A47 North Tuddenham to Easton Dualling

9.29 Applicant's Written Summary of Oral Submissions at ISH3

**APPLICANT'S WRITTEN SUMMARY OF ORAL SUBMISSIONS
AT ISH3**

Regulation Number:	Rule 8(1)(c)
Planning Inspectorate Scheme Reference	TR010038
Application Document Reference	TR010038/EXAM/9.29
Author:	A47 North Tuddenham to Easton Project Team, Highways England

SECTION F - 'F' PART 1 OF 3
SCALE 1 : 200

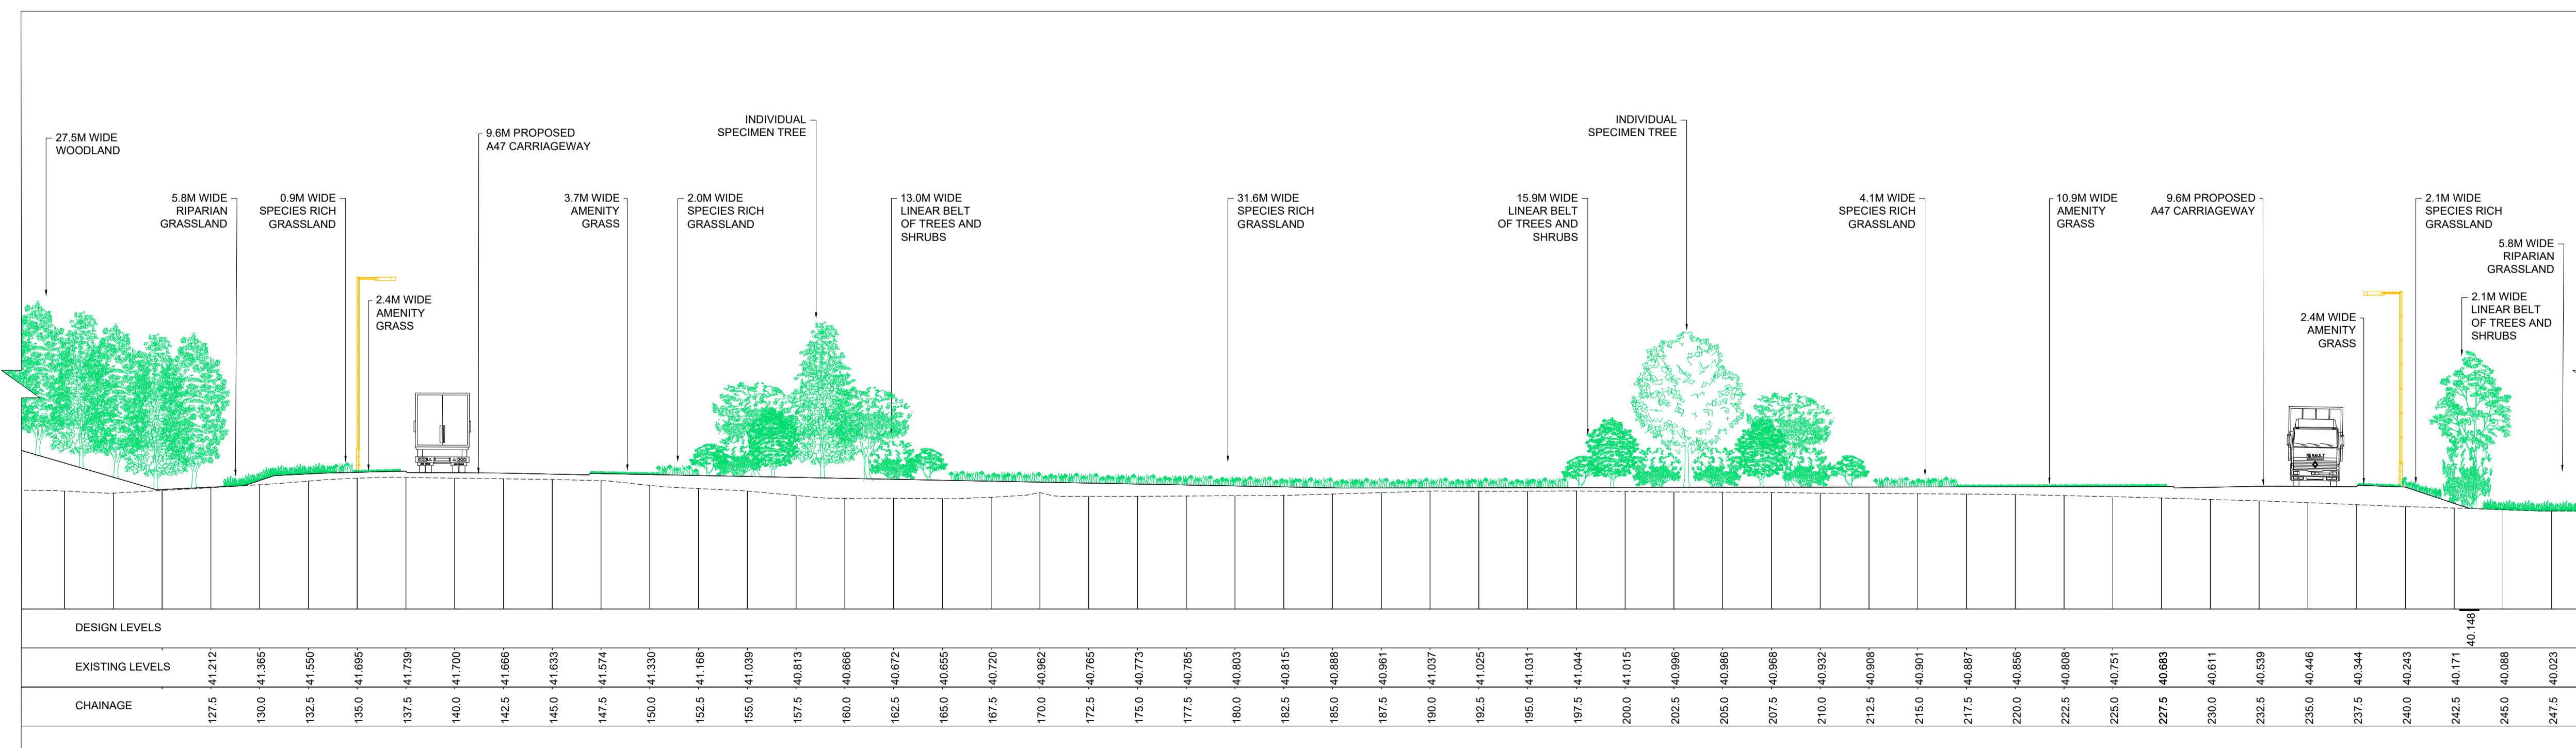
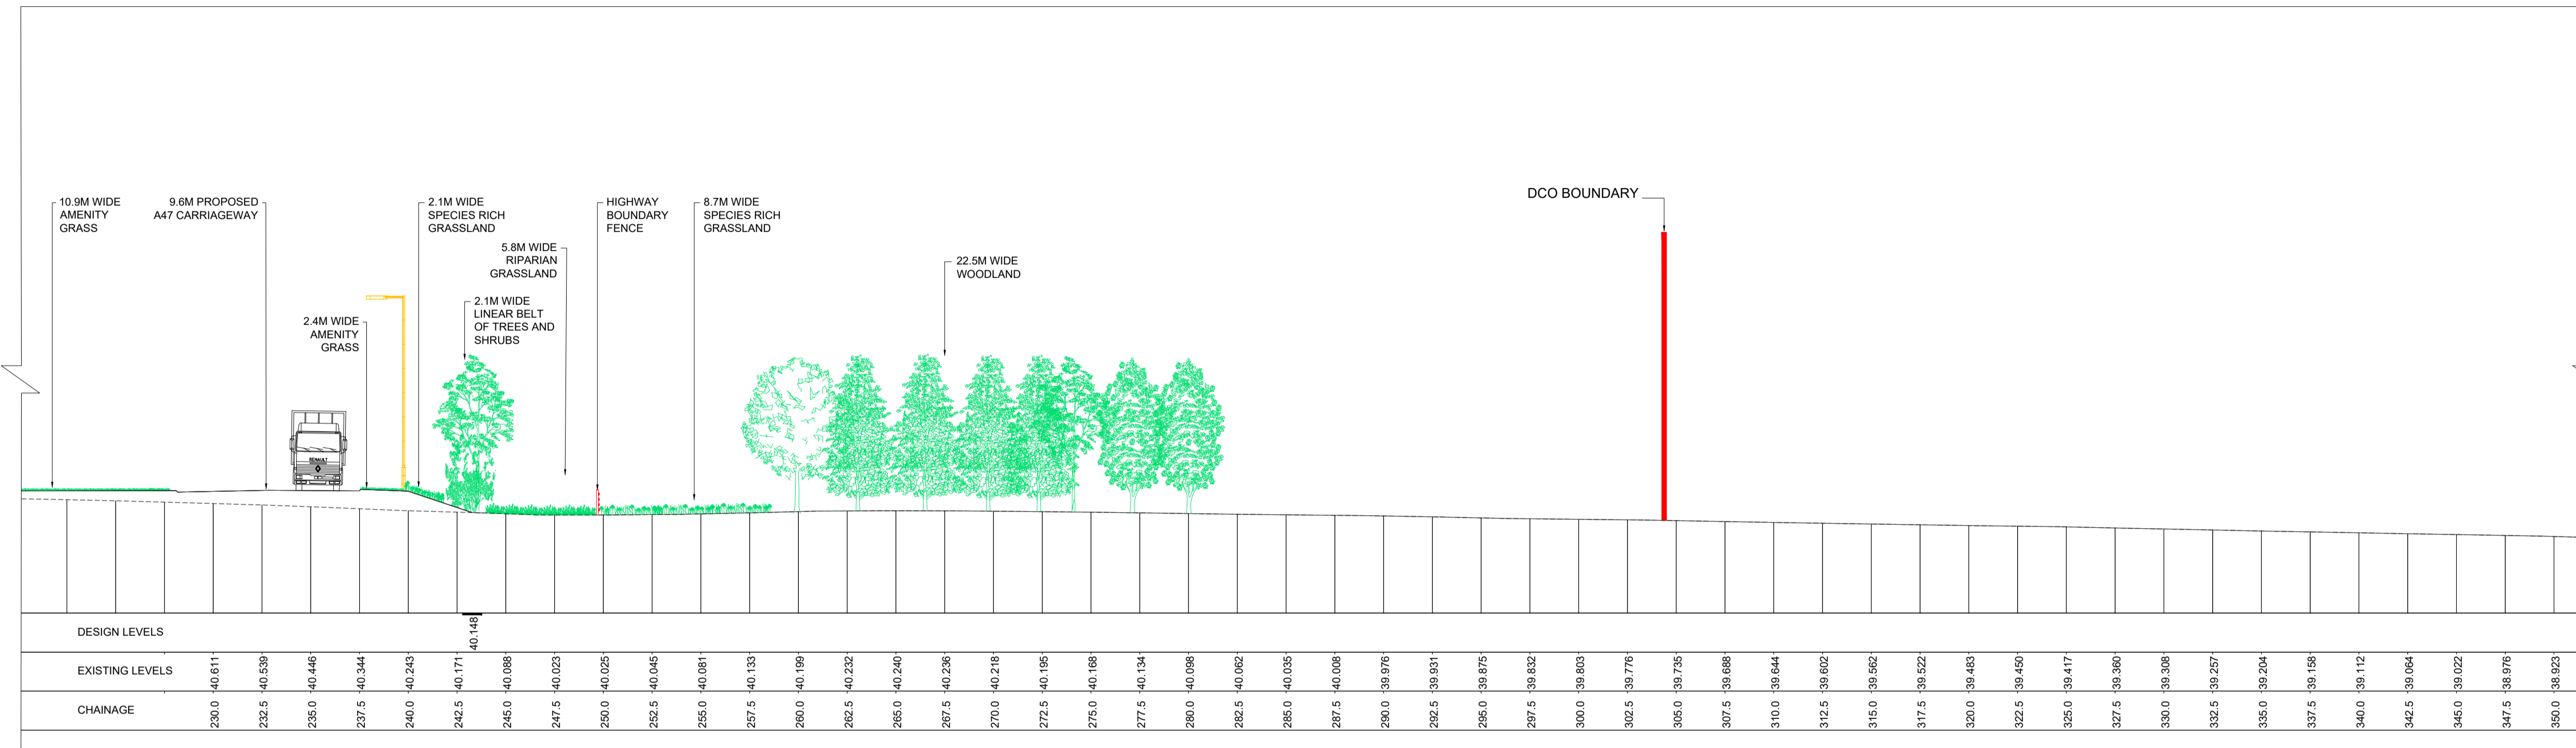
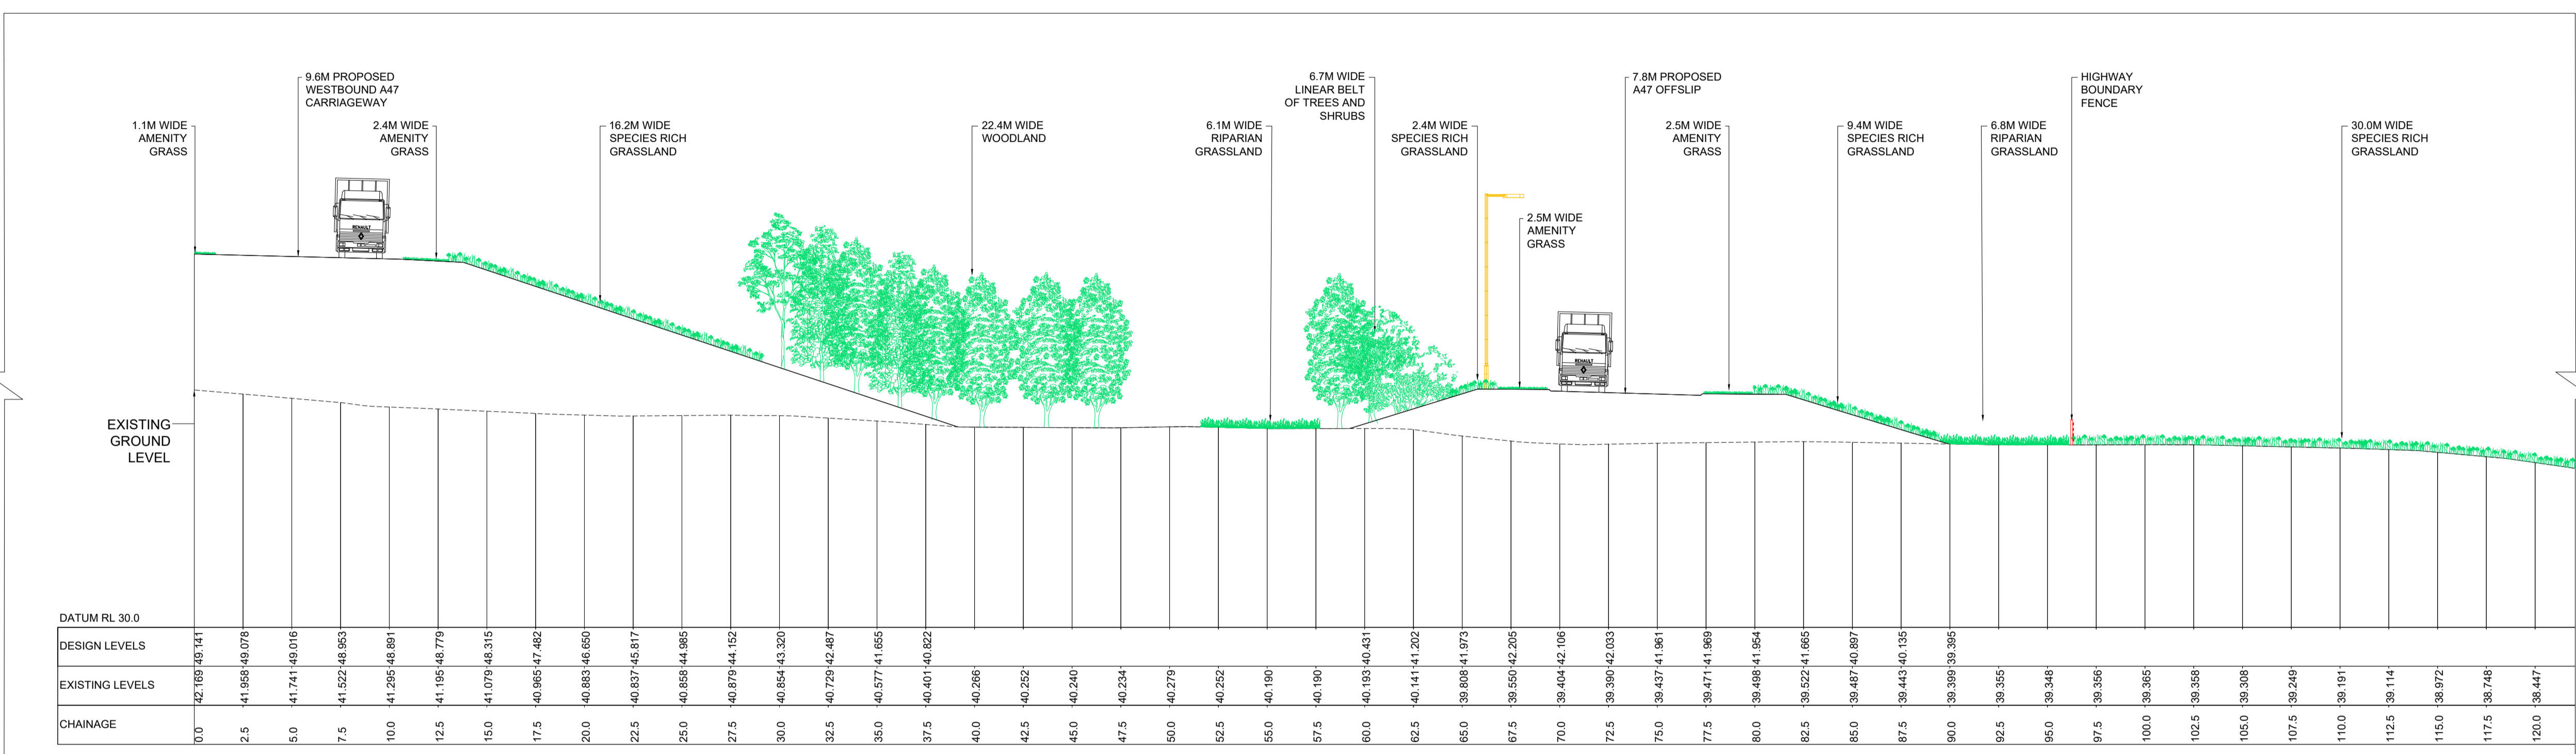
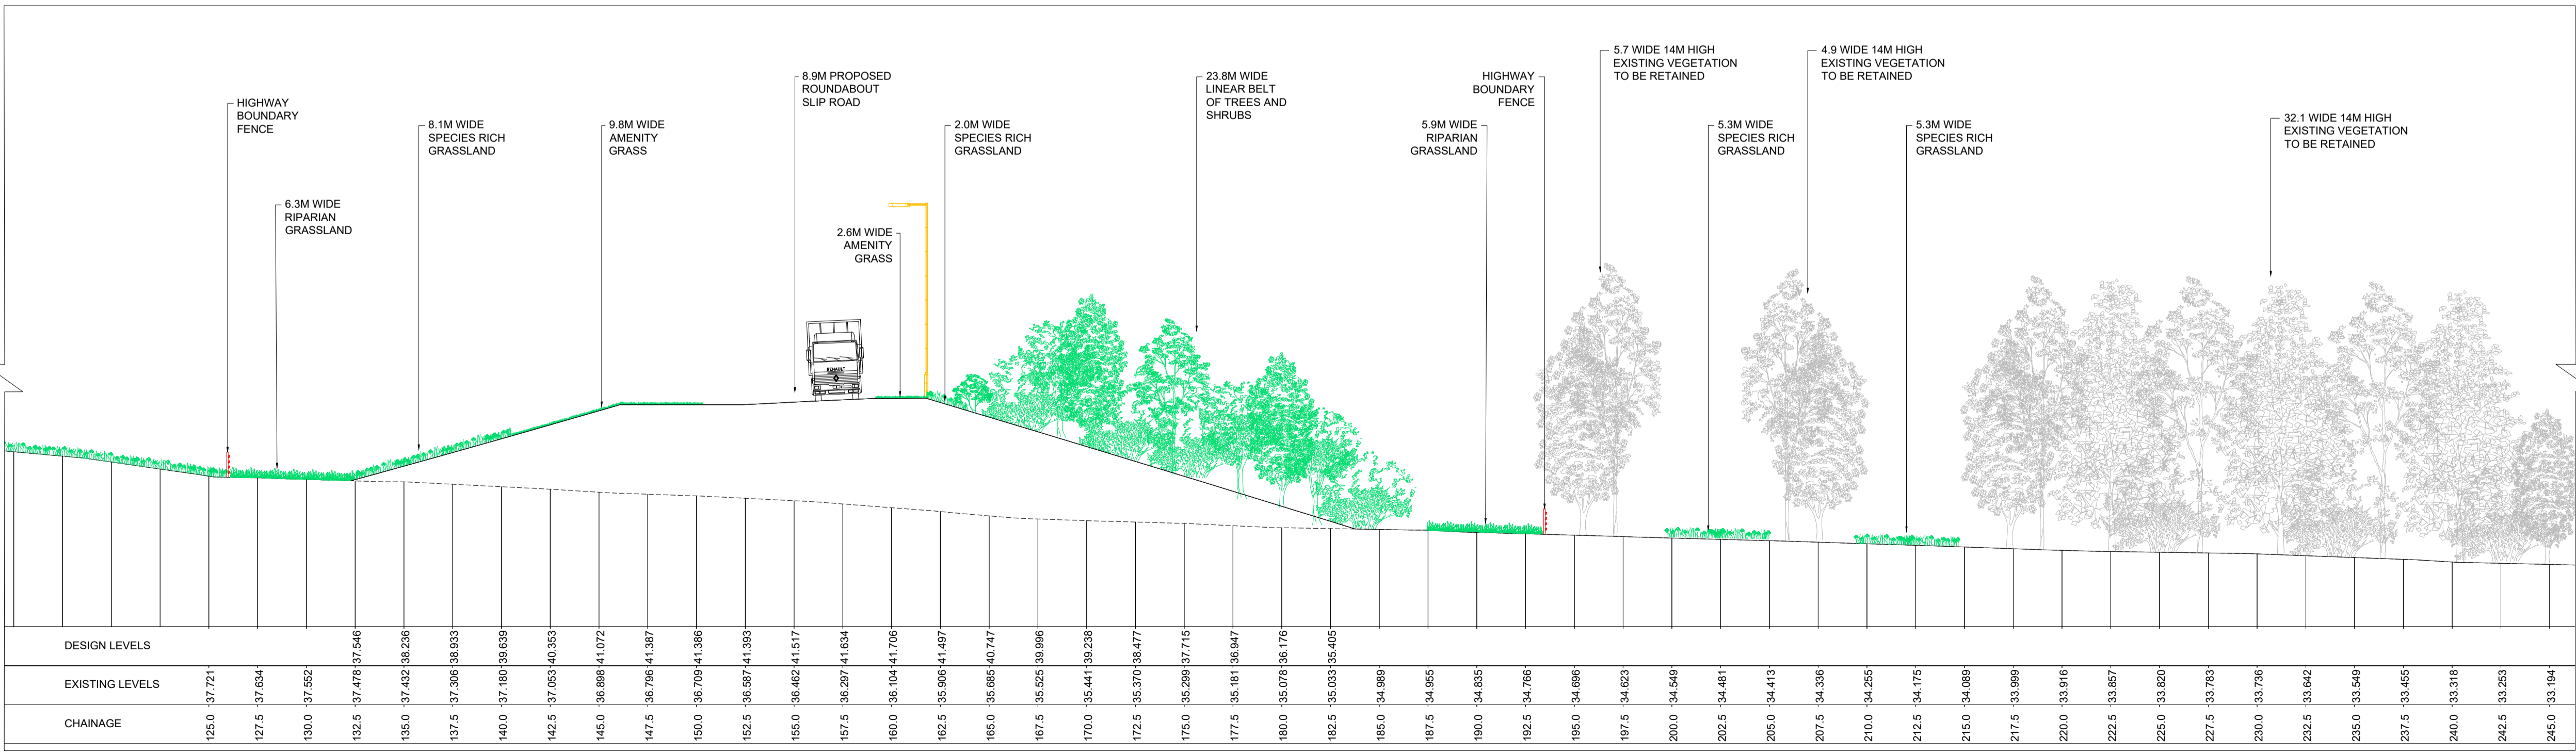
41.	<p>The ExA highlighted a question raised in a previous ISH in relation to the methodology used for cross-sectional drawings.</p> <p>The ExA also queried whether any lighting columns are shown on the cross-sections.</p> <p>George Josselyn asked if it would be possible to delineate the existing trees with those proposed by a change in the colouring and if a line could be drawn showing the limit of the permanent acquisition of land on the cross-section.</p>	<p>The Applicant stated that it would respond in writing to this question with a brief methodology on the preparation of the cross-sections Mr Josselyn referred to.</p> <p>The cross-sections were produced in line with the latest information and data, including topographic data, arboricultural data and the arboricultural masterplan (REP3-016) and are intended to show the scheme planting at a reasonable level of maturity. The existing (retained) trees are shown using data from the arboricultural assessment which makes the retained trees as accurate as possible on the sections.</p> <p>In relation to the lighting columns the Applicant stated that there are no lighting columns that directly dissect the section lines but that the Applicant will include indicative columns within areas to be lit to indicatively illustrate their relative scale and location.</p> <p>In relation to the cross-section drawings the Applicant highlighted that the limit of permanent acquisition is shown by reference to the Highway Boundary Fence. Existing vegetation has also already been annotated on the plans.</p>	<p>Appendix A of this ISH3 hearing note contains updates to the cross-section drawings submitted as Appendix A to the 'Applicant's Response to the Examining Authority's Third Written Questions' (REP6-018). The approach to producing the cross-sections was as follows:</p> <ul style="list-style-type: none"> • The location of the sections was selected to give a range of illustrative material within the vicinity of the proposed junctions and based on a request from the landowners agent for sections at chainages through the road centreline and southwards into Berry Hall Estate. The Applicant reviewed the chainages and provided sections as required including an additional section (Section F-F) not requested by the landowner. • The sections were produced using the Scheme design submitted for Examination, existing topographical survey data and exported from the 3D modelling software.

Ref	Questions / Issues Raised at ISH3 and Hearing Action Points	Summary of Applicant's Response at ISH3	Applicant's Written Response
		<p>The applicant will update the visual representation of existing/proposed vegetation and the freehold boundary in a re-issue of the sections.</p>	<ul style="list-style-type: none"> • The retained existing tree cover is illustrated as accurately as possible, utilising project arboricultural information (refer to APP-094, Appendix 7.6). The height of retained existing trees is represented utilising surveyed heights from the arboricultural report, but does not account for future growth post that survey. • As part of the Scheme, the following key components are also shown: <ul style="list-style-type: none"> - Proposed mitigation planting. Planting information is taken from the Environmental Masterplan (AS-007) and is shown at 8m above proposed ground level, therefore linking to Table 7-6 of EIA Chapter 7 (APP-046) which defines planting heights at Year 15 of operation of the Scheme. - The proposed highway boundary is shown by inclusion of the "Highway Boundary Fence". - Indicative locations of lighting columns are shown at 10m in height, as assessed in the EIA. - Vehicles on the Scheme are shown at a maximum of 4m in height (above road level), the tallest vehicles being lorries.
